<b>CITY OF WESTMINSTER</b>			
<b>PLANNING APPLICATIONS COMMITTEE</b>	<b>Date</b> 2 February 2016	<b>Classification</b> For General Release	
<b>Report of</b> Director of Planning		<b>Ward(s) involved</b> Bryanston And Dorset Square	
<b>Subject of Report</b>	<b>33 Seymour Place, London, W1H 5AP,</b>		
<b>Proposal</b>	Erection of a two storey roof extension on the northern building for use as five residential flats and creation of a new ground floor entrance door in Seymour Place with associated terraces at third and new fourth and fifth floor levels and on the flat roof of the southern building. Erection of extensions at rear first to new fourth floor to accommodate the new residential access, and a new plant room at rear first floor level.		
<b>Agent</b>	JLL		
<b>On behalf of</b>	WLS Seymour Place Ltd		
<b>Registered Number</b>	15/02263/FULL 15/02264/LBC	<b>Date amended/ completed</b>	13 March 2015

33 SEYMOUR PLACE WITH SAU

Existing and proposed front elevation

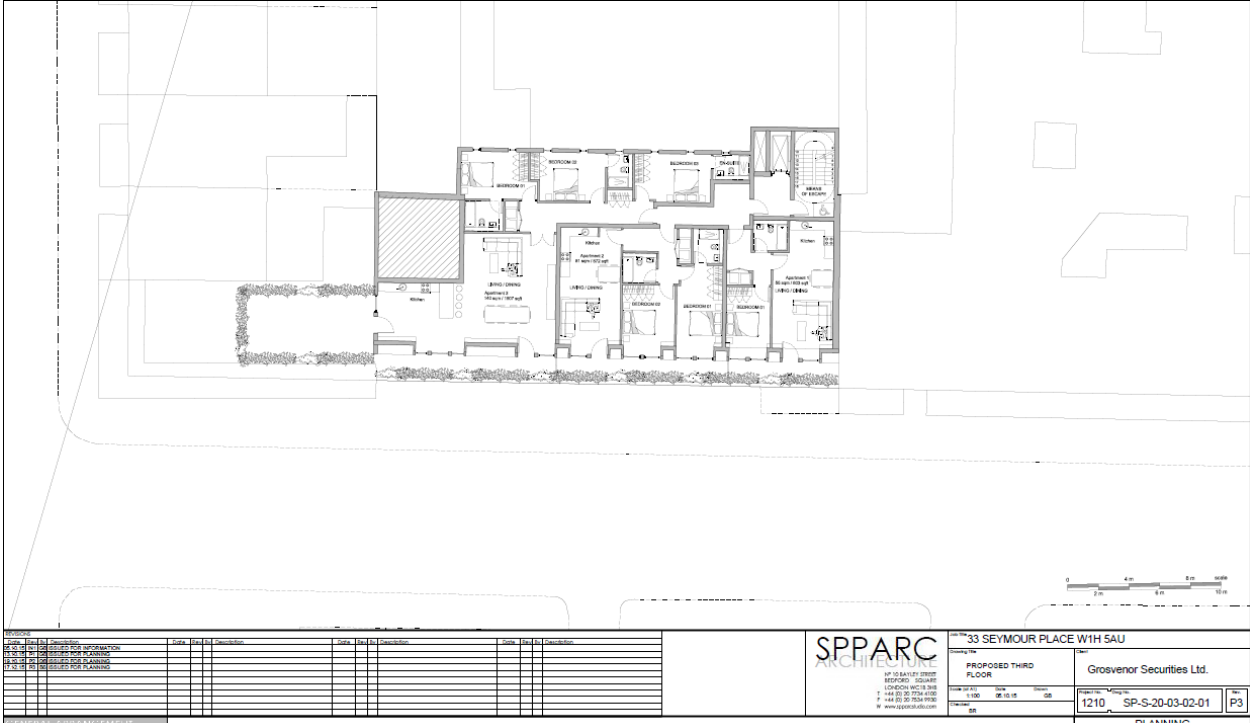
At the front the roof extension takes the form of a double height mansard, with projecting dormers at third floor level and recessed dormers at fourth floor level. The shallow secondary pitch means that the bulk of the roof is much reduced in street level views. This is a traditional mansard form, in line with the supplementary planning guidance on roofs, and is considered acceptable. There will be no plant on the top of the roof, but some is contained within the rear extension.

Proposed third and fourth floor

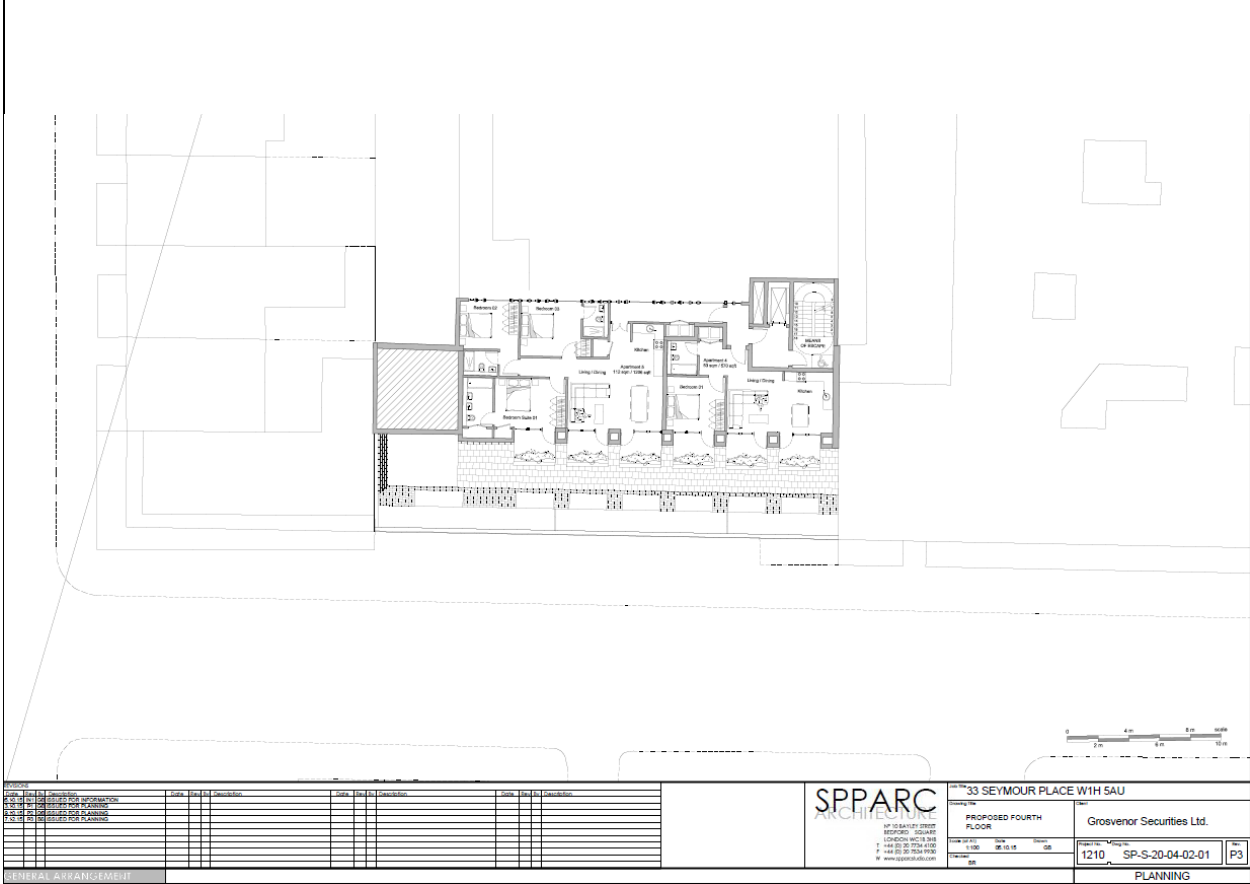
Objections have been received from residential flats opposite the application site on the grounds that there will be a loss of privacy from the proposed residential units at third and fourth floor level. It is recognised that there is already a degree of mutual overlooking between the two buildings. The objector notes as the application site is not used on a 24 hour basis and the impact of this mutual overlooking dissipates in the evening. The new residential windows are set back from the building edge by 2m, however a terrace area is proposed to the front of these set-back windows. The windows directly opposite the new extension, within 34 Seymour Place are set within the mansard and it is not considered that creation of a terrace in this location will cause a loss of privacy.

A terrace is also proposed to the roof of the southern building (third floor); this will be used by one of the proposed residential flats. An objection has been received from the top floor maisonette within 29 Upper Berkeley Street on the grounds that there will be a loss of privacy. It is considered that there is the potential for people using the terrace to overlook the objector's property. It is considered that the terrace should be set back from the rear elevation by 2m and its length along the roof by 3m to prevent a loss of privacy, and this is to be secured by condition. On this basis the proposed terrace is considered acceptable.

An objection has been received to the third floor terrace on noise grounds. The terrace is proposed to be reduced in size by condition, which will result in a terrace comprising 18sqm. It is considered that the terrace is not so large to have an impact on neighbouring residents and is acceptable.

- the terrace at third floor level must be set back from the rear elevation by 2m and set back (in length) from the Upper Berkeley Street by 3m.
